NOTICE No. S.2591

MULTIPLE ASPECT SIGNALLING

GLOUCESTER

(Stage 3B—Tuffley—Standish Junction)

GLOUCESTER M. A. S. STAGE 3 B

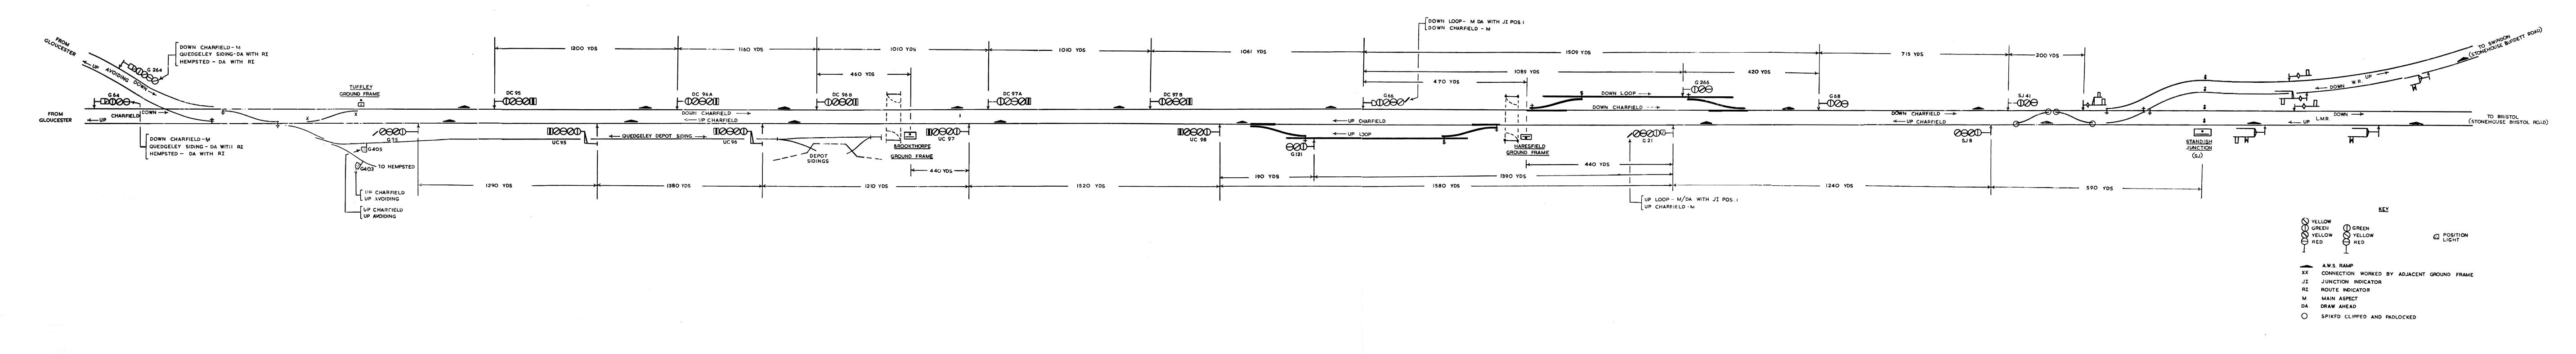
N.B. At Standish Junction the Lower Distant Arm on the Up L.M.R. Home together with the associated A.W.S. Ramp should be deleted from the enclosed diagram.
